MARIN COUNTY PARKS

Veronica Pearson left the County of Marin on November 05, 2024. My name is Michelle Julene, and I am the Regulatory Open Space Planner with Marin County Parks and Open Space District. I have been involved with the McInnis Marsh project for the past few years and will be providing on-going support on regulatory issues and resolution of the Bay Trail realignment.

Thank you for reviewing the McInnis Trail Resilience Memo prepared by ESA dated August 28, 2024 and providing your questions and comments on September 27, 2024. Just before receiving your email, Marin County Parks (MCP) and the Marin County Department of Public Works (DPW) met with the San Francisco Bay Restoration Regulatory Integration Team (BRRIT) on the proposed Gallinas Creek Geomorphic Dredge and McInnis Marsh Restoration project on September 25, 2024. On October 31, 2024, the BRRIT recently provided their comments and questions from that meeting, including some from San Francisco Bay Conservation and Development (BCDC) and from the California Department of Fish and Wildlife (CDFW) that pertain to the proposed Bay Trail alignment at McInnis Marsh.

This correspondence includes responses to the ques

Figure 1

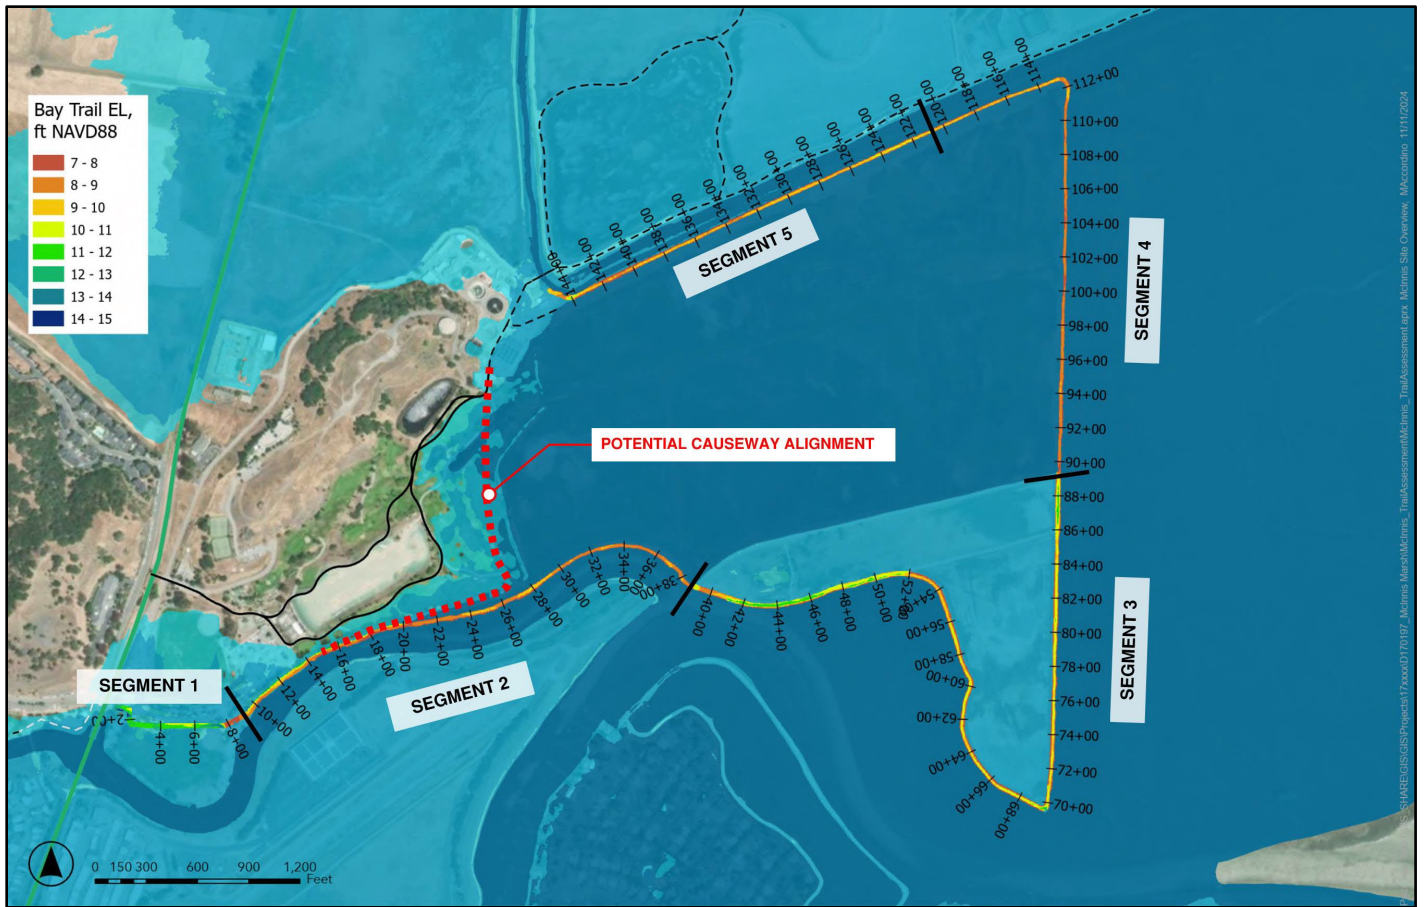
- 1) Although we appreciate the discussion comparing the two Bay Trail realignment options in the memo, we had discussed the possibility of looking at an alignment that would run along the eastern edge of the existing golf course. As part of that, we discussed the possibility of looking at a raised boardwalk along that eastern edge of the golf course. Although we appreciate that boardwalks can increase capital costs, this segment would be much shorter than the “hold the line” option evaluated in the memo. Was there any analysis of this option as part of the evaluation process? Our mail goal is to maintain a water of Bay’s edge experience for Bay Trail users at McInnis as retreat becomes a reality.**

Additional Considerations: In considering Bay Trail realignment scenarios, MCP based potential future alignments on a realistic scenario of where investments would be sensible in relation to the future connectivity of the trail to neighboring lands. A causeway is a considerable investment and warrants use of a conservative planning scenario to achieve an appropriate (75+ years) design life. This extended design life under conservative SLR scenarios requires planning to accommodate up to 4.9 to 6.6 feet of SLR (per OPC 2024, Intermediate-High and High scenarios). With this amount of sea-level rise, it is unrealistic to assume the trail could continue north of McInnis Park along its existing alignment, on the existing embankments on LGVSD lands around the wastewater ponds, and on old farm berms farther north. A more sensible trail alignment for these high amounts of sea-level rise would be along the SMART tracks, which would allow for coordinated SLR adaptation between the trail and railroad infrastructure, allowing for cost sharing for easement acquisition and trail/railroad embankment construction, and enabling greater opportunities for future tidal habitat restoration and preservation. Please refer to Figure 1.

Figure 2

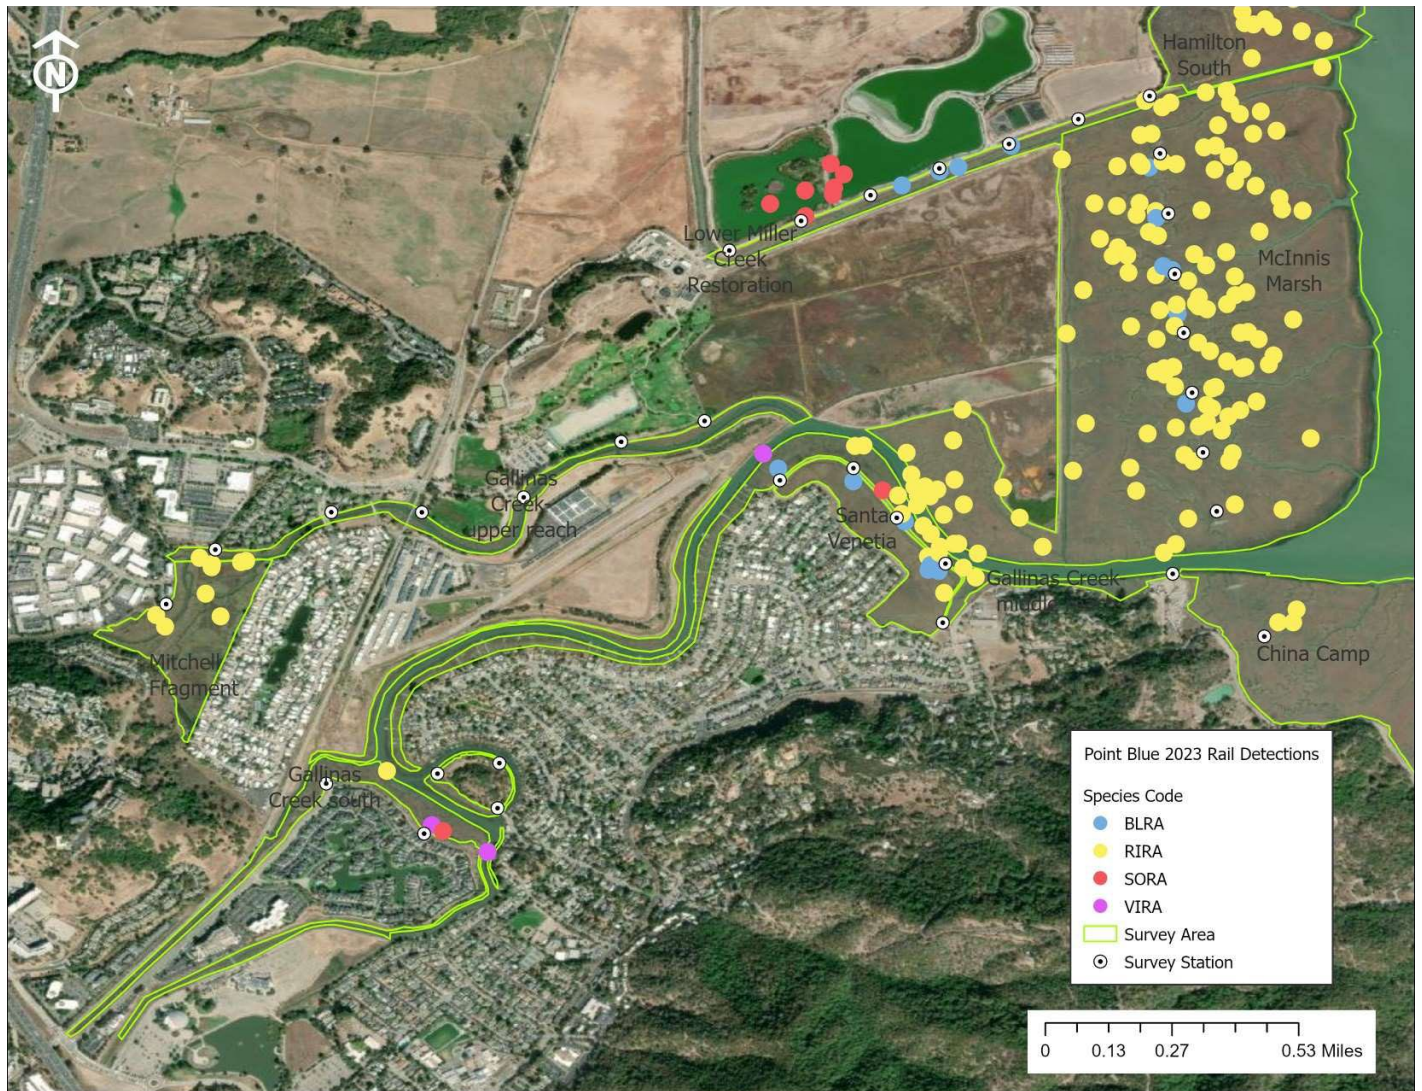
6. Although we understand the need to balance habitat/wildlife with public access, a 200-foot buffer is a significant distance and a significant impact on trail placement. To help in understanding the potential impacts in the area, is there a map that shows the historical locations of Ridgeway Rail nests?

Please reference the response to Question 1 and Figure 2 which shows the locations of Ridgeway's rails call locations. Rails are secretive birds, and it is not easy to locate their nests. Therefore, their locations are determined by call and response, and not by field surveys to locate nests. California black rail and Virginia rail are also located at the marsh. As mentioned previously and in the McInnis Marsh Trail Resiliency Memo, MCP has consulted with Point Blue to determine an appropriate trail location and buffer distance from rail habitat to protect this sensitive species. In addition to these bird species, the federally and state endangered salt marsh harvest mouse is also present throughout the marsh.
